To: Ken Upmal, P.E., Roadway Design Project Manager
SPM CEE

From: Stephen Madden, Geotechnical Engineer via Callie Ewald, P.E., Geotechnical Engineering Manager

Subject: Poultney STP 015-2(9) – Geotechnical Memo

Figure 2.1: Proposed Typical Section with FOS = 1.01

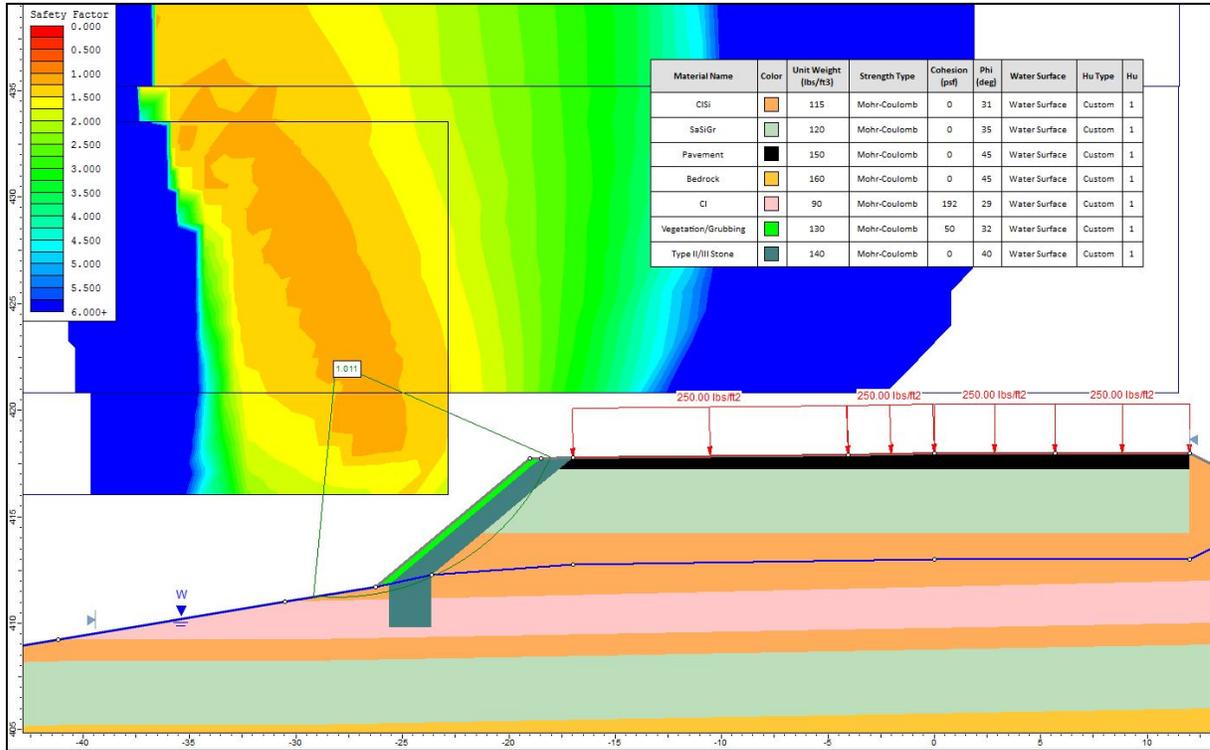
any shape and a minimum factor of safety of 1.3 shall be used for slopes adjacent to but not directly supporting structures. Below, in Figure 2.1, is the model output using the Spencer method showing the minimum factor of safety of 1.01 under the proposed typical section conditions. The proposed slope steepening and stone fill does not meet design requirements.

In order to maintain stability along the proposed 1:1.2 slope and prevent both shoulder instability and a larger slope stability issue, we recommend installing a series of geogrid reinforcement layers along the over-steepened slope for the 500 foot length of guard-railed section. From the analyses, it was determined that a minimum tensile strength of 1000 lb/ft is required in order to raise the global factor of safety to 1.3. Figure 2.2 shows the typical section with the acceptable factor of safety = 1.31, utilizing three layers of 7 foot long geogrid with 1.0 foot vertical spacing.

Figure 3.1: Geogrid Wrapped Face Typical

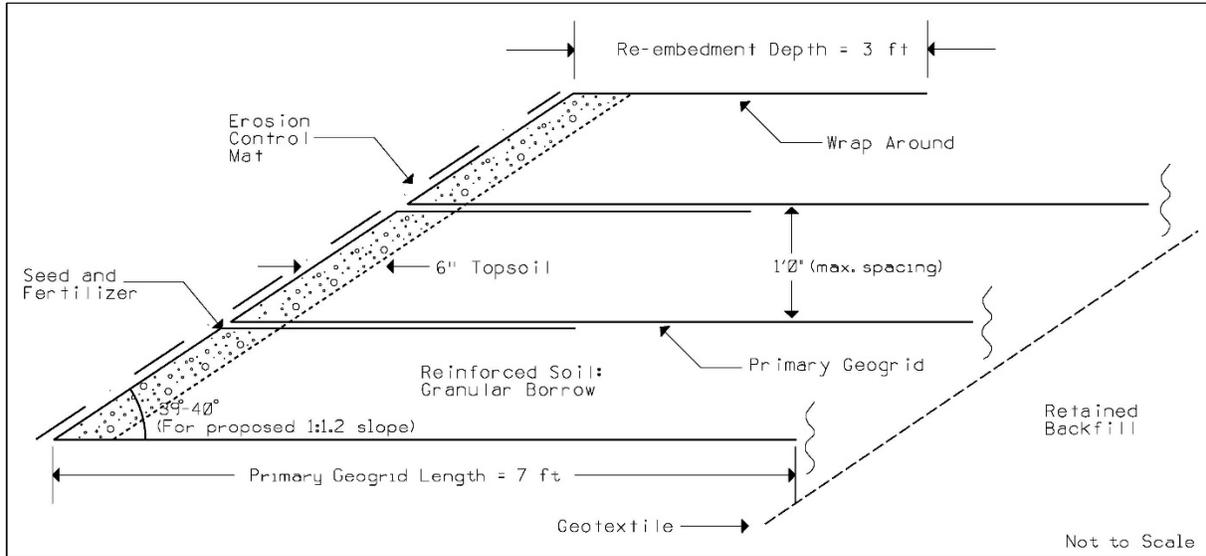
The geogrid reinforcement is required to be constructed with a wrapped face to maintain the stability of the slope. The geogrid re-embedment length should be at least 3 feet. A detail is shown below in Figure 3.1.

Treatment of the outward face needs to be taken care of to prevent ultraviolet light exposure from deteriorating the geosynthetic over time as well as to minimize erosion due to rainfall and run-off. We recommend a temporary synthetic erosion control mat meeting the requirements of VTrans 2011 *Standard Specifications for Construction*, Item 755.11(a) for Temporary Erosion Matting to protect the reinforced slope and provide suitable growing conditions for vegetation. We also recommend a minimum of 6 inches of topsoil be placed on the face and properly seeded according to Item 755.04 Seed to ensure vegetation is established within a short period of time.
